ADDENDUM #1

Project: Milwaukee Electric Tool Expansion
Phase II, Existing Facility Repairs
Greenwood, Mississippi

Date Issued: April 12, 2016

ADDENDUM NO. 1

DATE: 02/20/18
PROJECT: P1.5R1

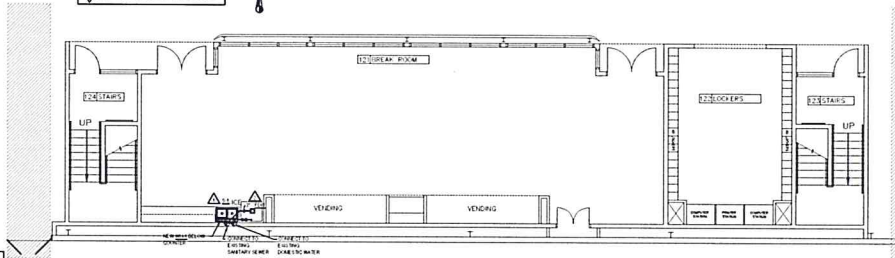
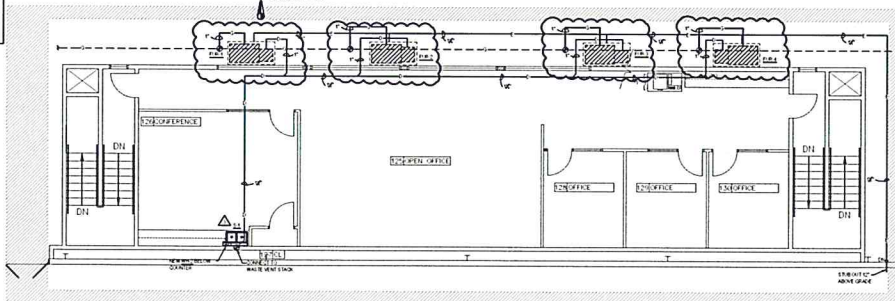
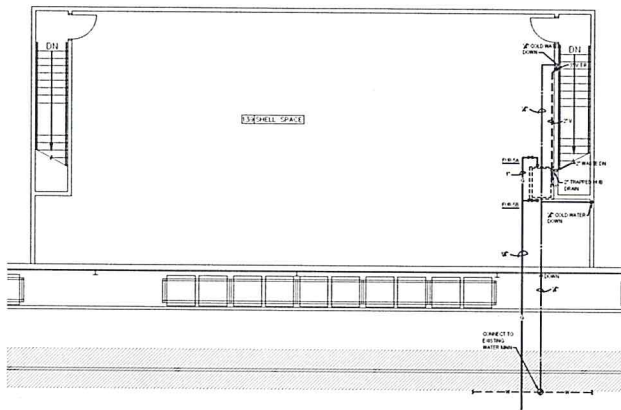
- Item No. 3: Drawing, Sheet P1.5: Add gas piping connection to furnaces FUR-1, FUR-2, FUR-3, and FUR-4 as shown on attached Drawing P1.5R1.
- Item No. 4: Drawing, Sheet M1.1: Add Alternate #1 designations as shown on attached Drawing M1.1R1.
- Item No. 5: Drawing, Sheet M1.8: Add Alternate #2 designation and Alternate #2 location for FUR5A and FUR5B as shown on attached Drawing M1.8R1.

SHEET #
P1.6R1

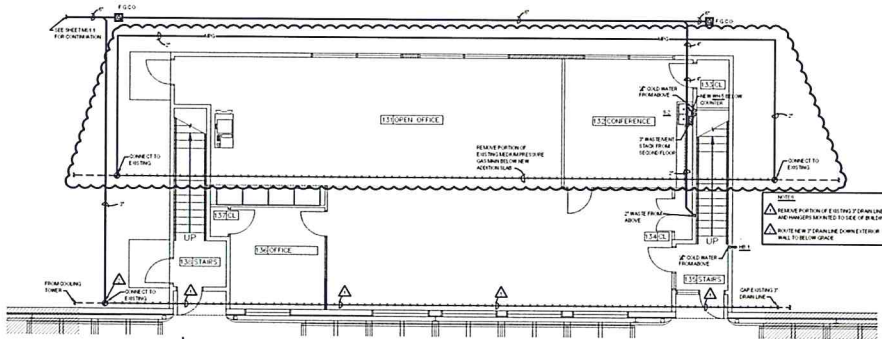
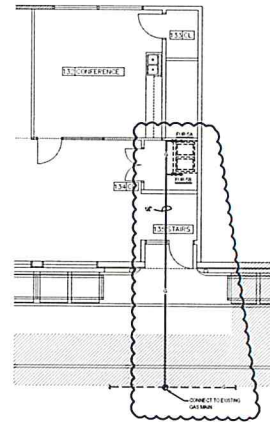
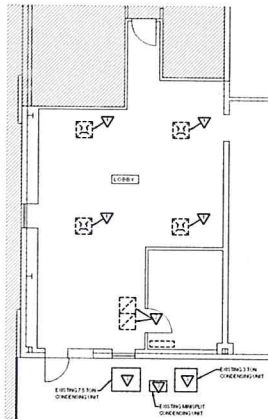
Item No. 2: Drawings, Sheet P1.6: Add underground gas piping to be relocated and gas piping to furnaces FUR5A and FUR5B as shown on attached Drawing P1.6R1.

TITLE: SECOND FLOOR
RENO FLOOR
PLANS - H.V.A.C.
SHEET:
M1.8R1

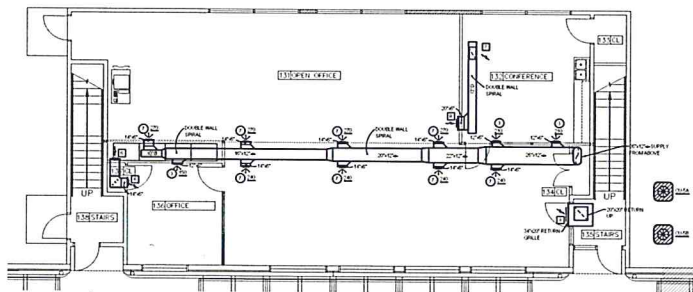
8. Revision - Refer to drawings 3/A0.1 and 1/M1.8: Furnaces 5A and 5B located on the second floor shall be relocated to Closet 133 on the first floor as part of Alternate #2.

4/A1.8 REVISED 04.12.16

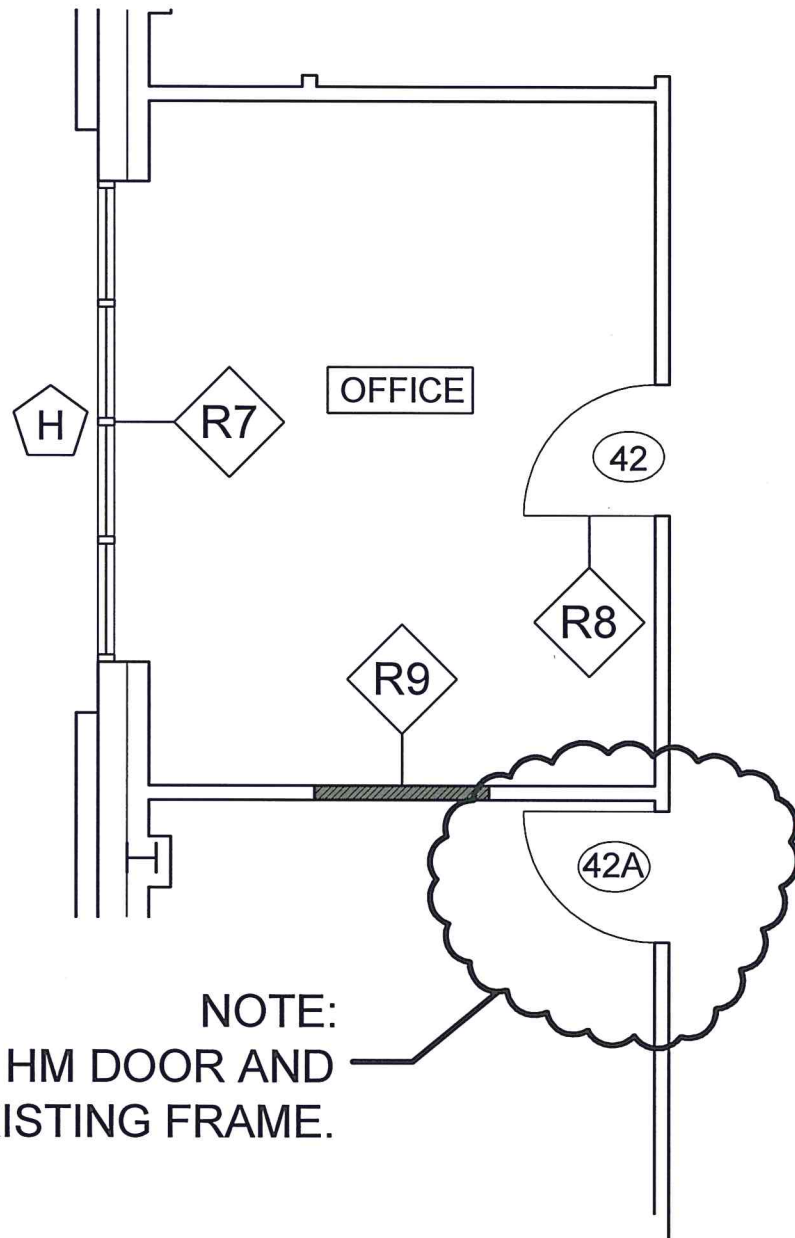
11. Revision – Refer to drawings 3/A1.2: Provide a 6' deep x 10' wide concrete pad at entrance Door #05.
12. Revision – Refer to drawings 3/A1.2: Refer to Project Manual Section 012100/3/3.3 Schedule of Allowances. Add item "C" - Provide allowance for construction of an access ramp from the new sidewalk to the existing parking area - \$6,000.
13. Revision – Refer to 2/A1.6, 3/A1.6, 2/A1.7: Delete all references to "New Rubber Base", All areas to receive WB1 - 4" wood base, ptd.
14. Mechanical items: Refer to attached Addendum #1 dated April 11, 2016 for mechanical and plumbing items.
15. Addition – Refer to attached revised drawing 4/A1.8. Add new HM door and hardware to existing frame at opening 42A.

NOTE:
PROVIDE NEW HM DOOR AND
HARDWARE IN EXISTING FRAME.
